Y17/0016/SH Erection of single storey rear extensions together with other external alterations and erection of an outbuilding at Garden Cottage, Dungeness Road, Dungeness, Romney Marsh TN29 9NF.

**Non-material minor amendment to include 2No. Velux conservation rooflight windows and 1No. replacement window associated with the retention of the existing first floor area.
Covering Statement**

VELUX conservation roof windows

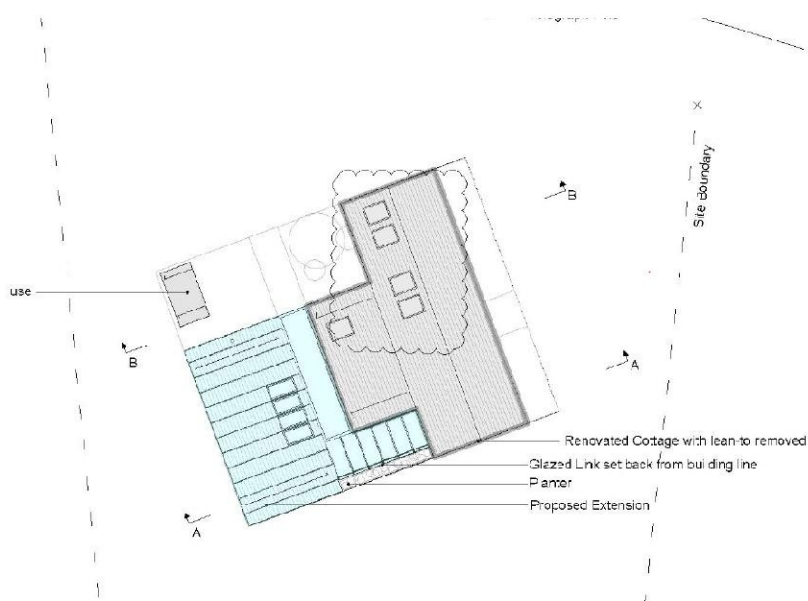
Two Velux conservation rooflight windows RL4 and RL5 shown on Drawing PL25C are proposed in addition to one currently approved. The number of rooflights on the higher part of the roof will therefore total 3.

The roof windows RL4 and RL5 are specified as conservation style Velux rooflights MK08 (780 x 1398mm) with recessed slate flashing finished in black with recessed slate flashing and central glazing bar. Typical details are shown in the Appendix to this document.

Unlike its competitors the Velux conservation rooflight is suitable for this coastal environment.
